Heritage Preservation Commission Design Review Application

Street and number: 511 Grand Hill Zip Code: 55102

building railing on top of 3-season porch on S.E. corner of house due to existing door in dormer providing access to roof. Inspector red flagged due to safety issue, children in home. Railing to match existing railing on side of house. (see drawing)

RE: Foss Deck – Hand Railings (Structural Validation Letter)
511 Grand Hill
St Paul, MN 55102

Post: 4x4 Green treat w/cedar wrap
Railings: cedar
baluster: cedar
Paint: painted to match existing
1st floor east side deck
railing (see picture)

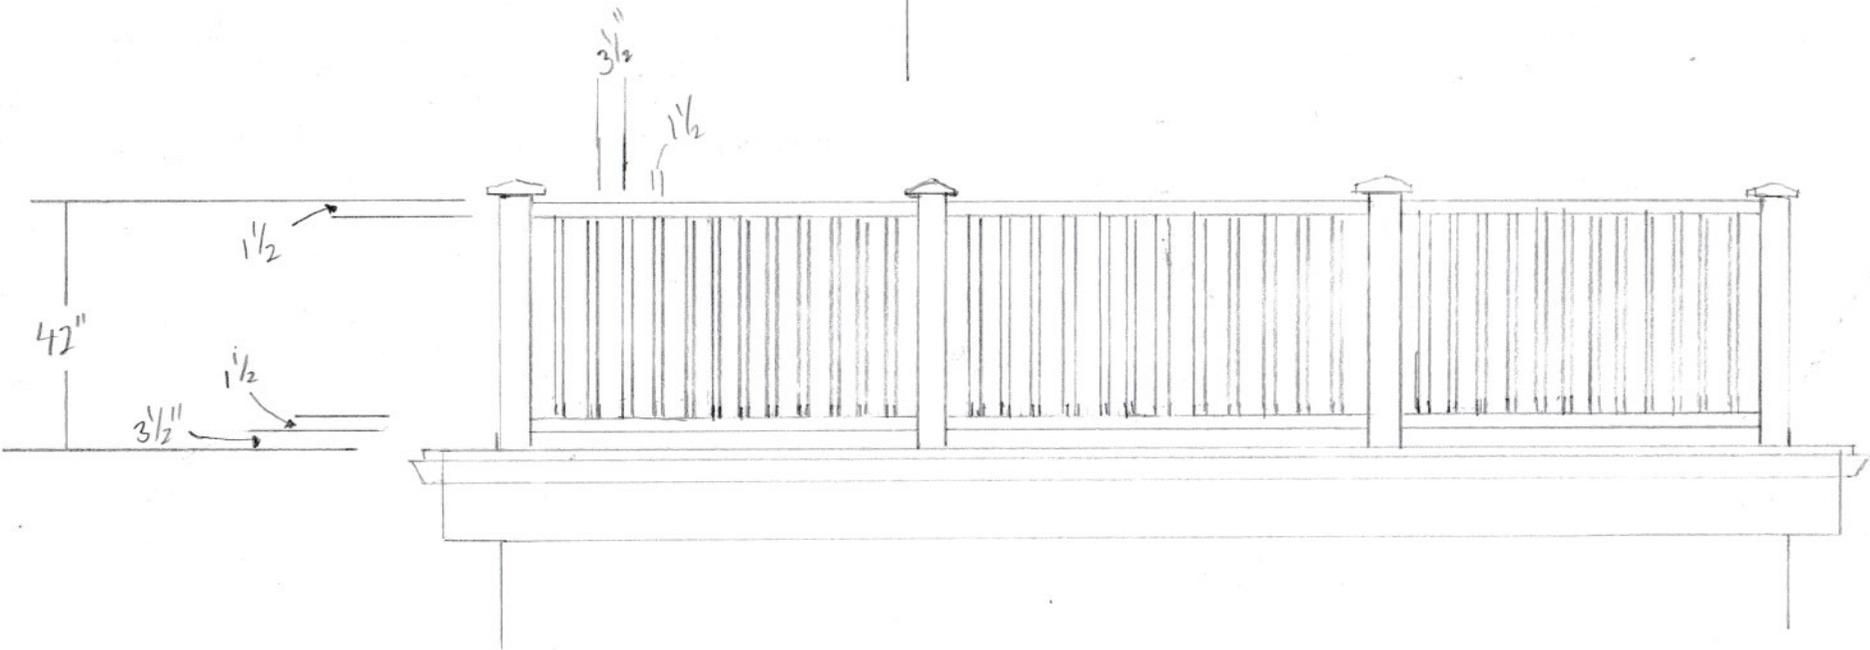
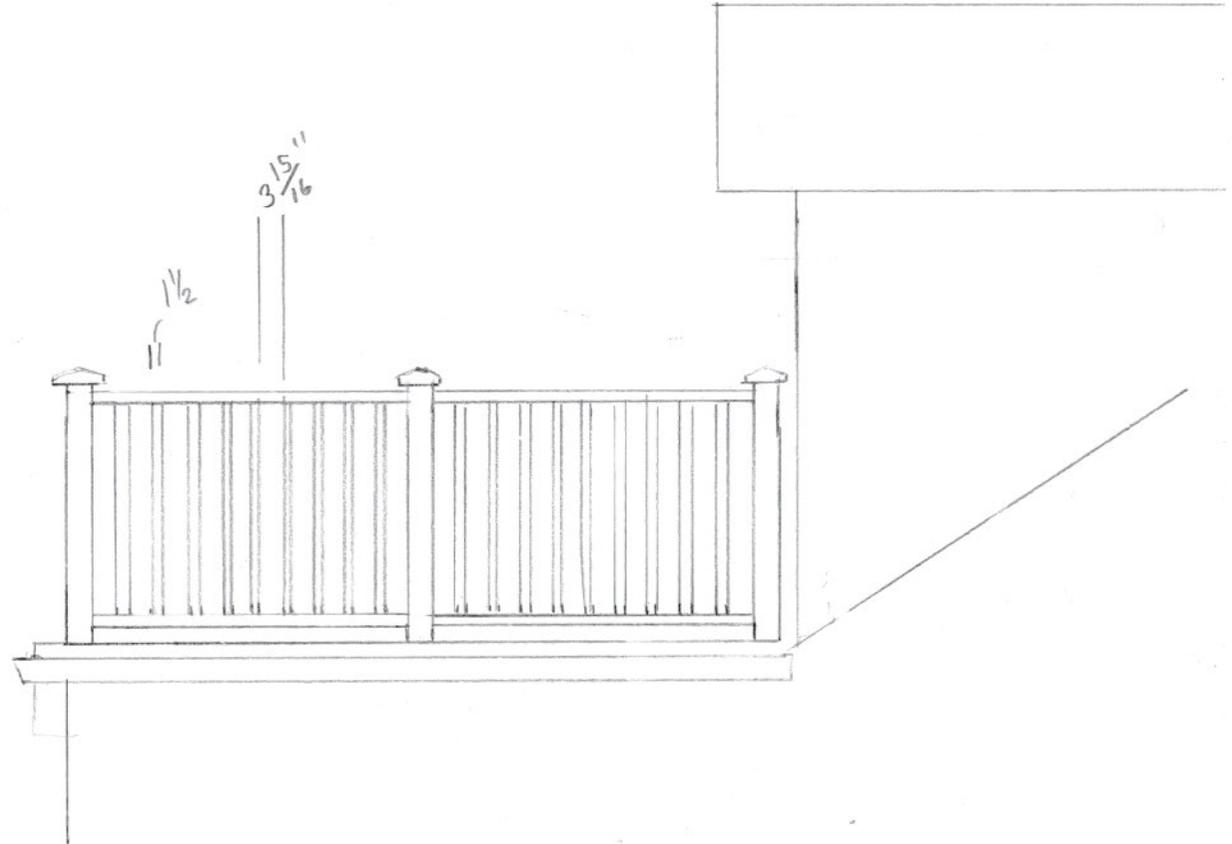
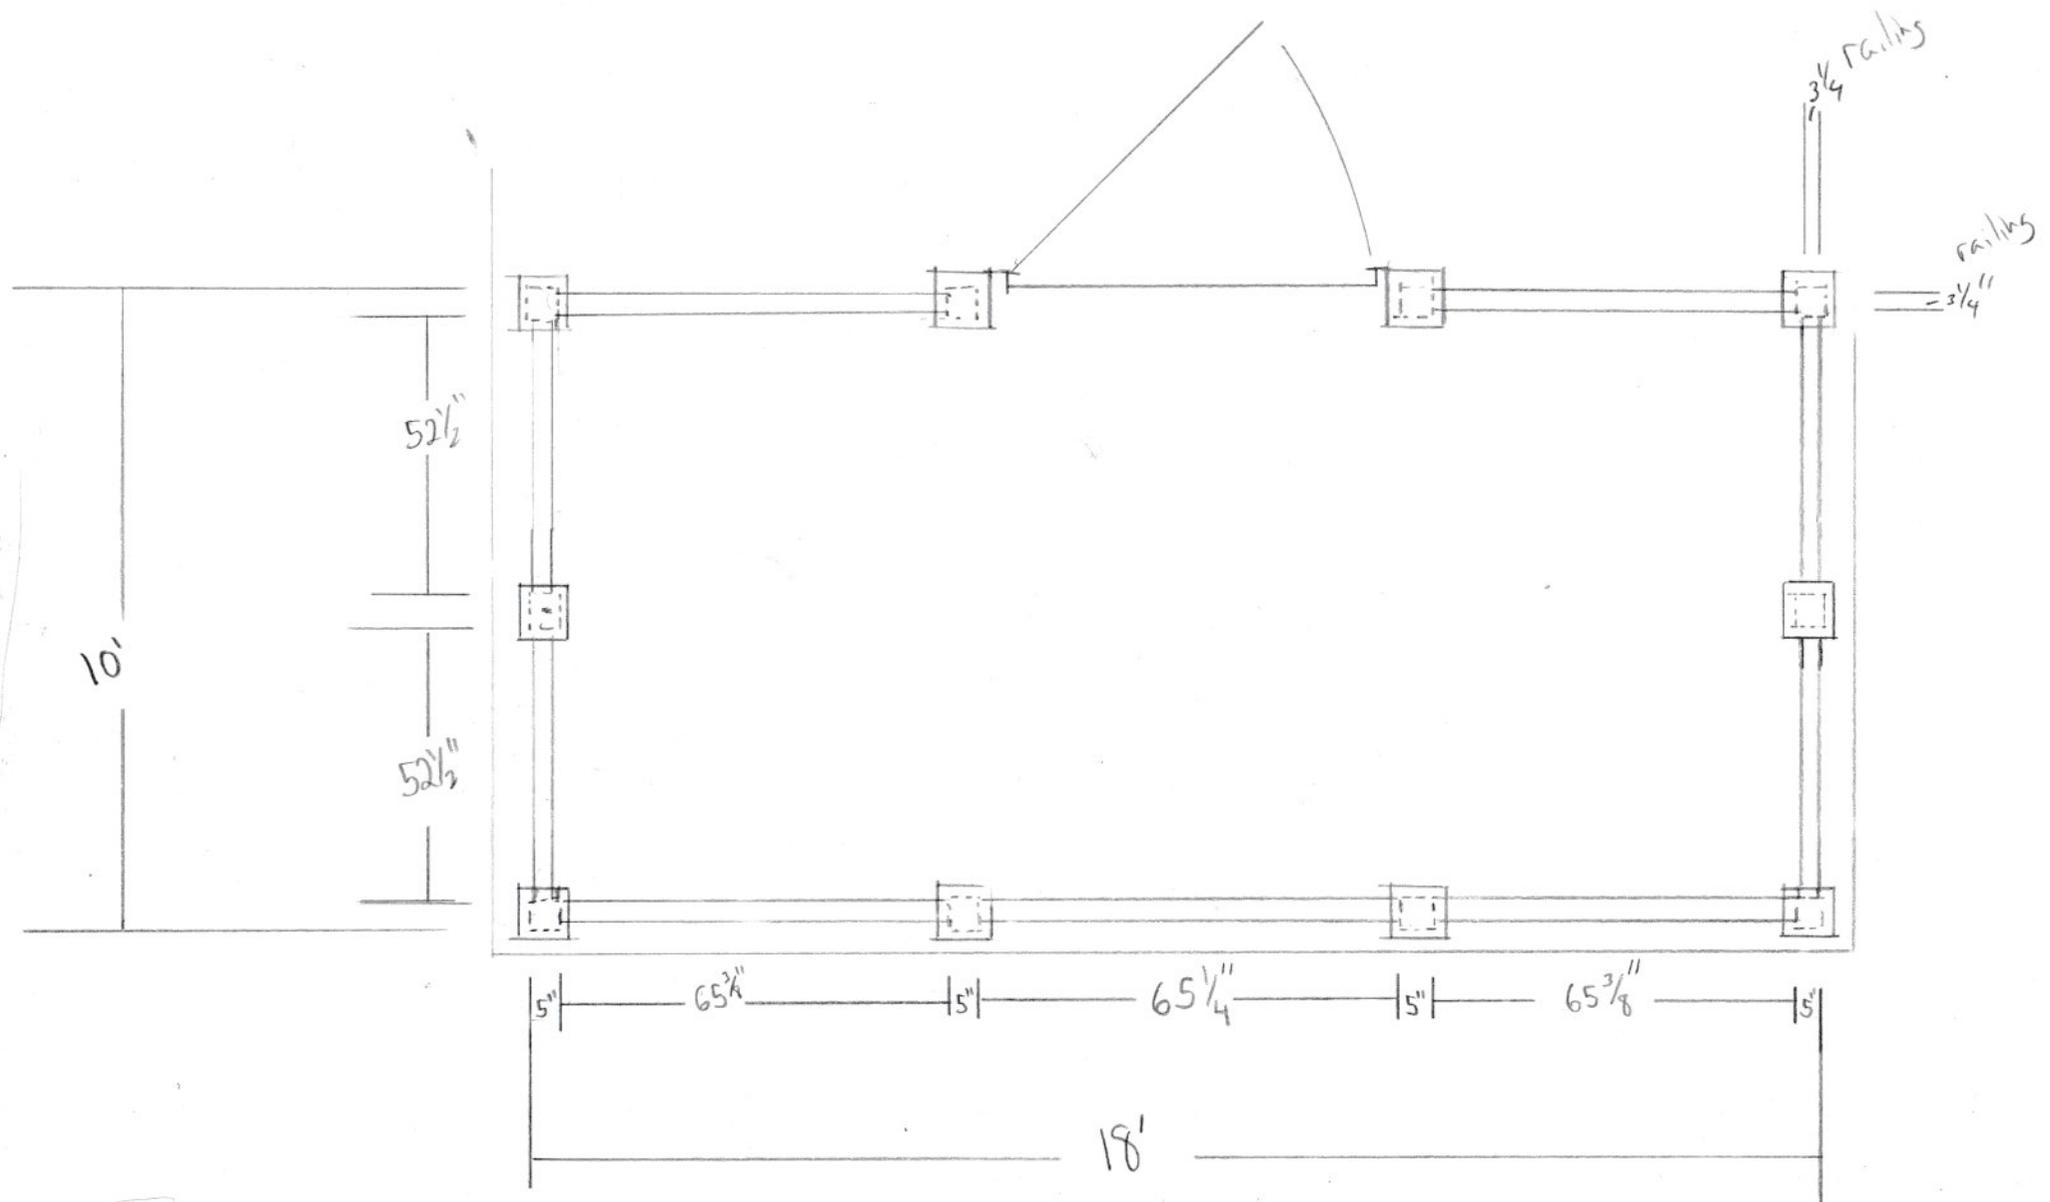
1. Which building inspector is requiring the railing on the roof?
2. If the dormer opening were changed to a window or Juliette balcony, would that satisfy code and not require a railing around the roof?
3. Can the roof over that sleeping porch handle the weight of a deck above? I don't see a floor system in the plans, nor do I see any engineers review of the structure to indicate that it can handle the additional load.

As to 1, the inspector that Wells Fargo (our lender) sent out prior to closing insisted on a balcony or a exterior door block visible from the street. I temporarily installed the door block so that we could close on the loan, and have since removed it. It was sufficiently unsightly that I cannot imagine it would have passed muster with the HPC.

As to 2, I'm not sure whether changing the door to a window or Juliette balcony would work, but the space there is clearly intended to be a balcony. Although other some houses in that historic district have Juliette balconies, none that I've seen have them adjacent to an un-railed balcony.

As to 3, you raise a good point, and we'll retain an engineer to confirm the load will work.

Third Floor Balcony (no safety rail)

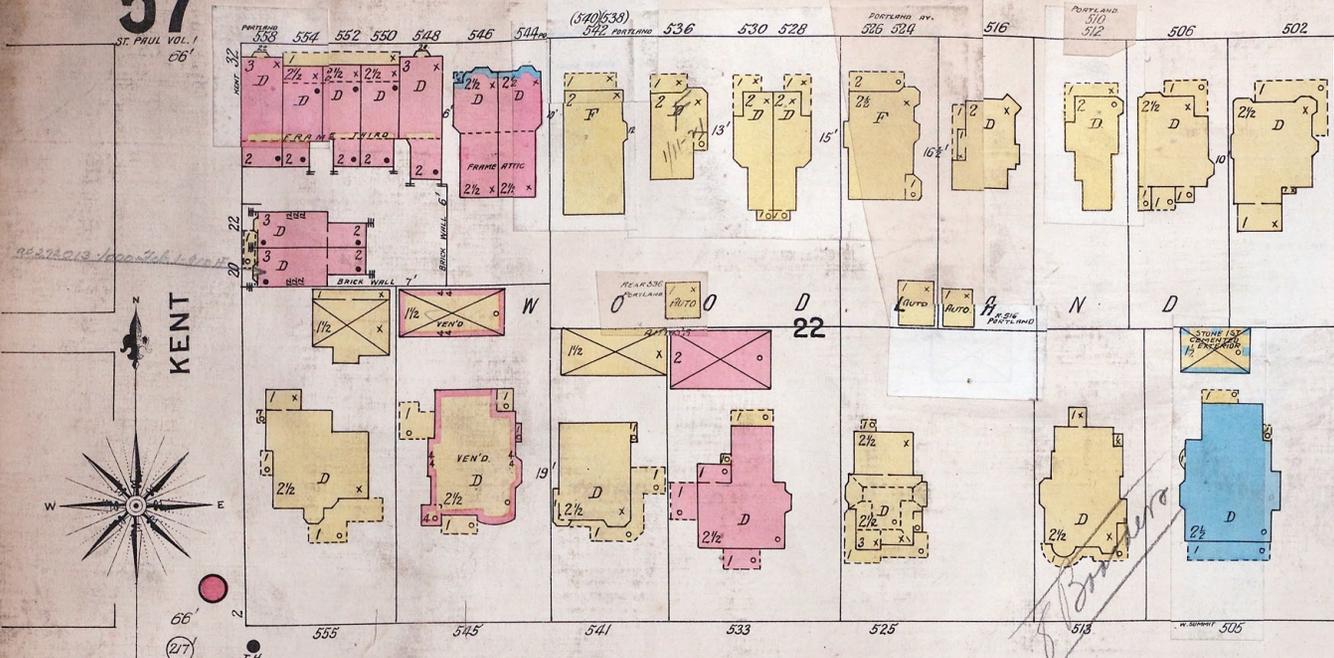
4. *Leg. Code §74.64(a)(3)* Staff was unable to find any evidence of a balustrade/railing existing atop the roof of the residence. The feature is proposed at the front and front-side elevations of the house and would have a high degree of visibility. The preservation program states, "*changes that create a false sense of historical development, such as adding conjectural features or elements from other historic properties, will not be undertaken.*" The proposal does not comply with this guideline.
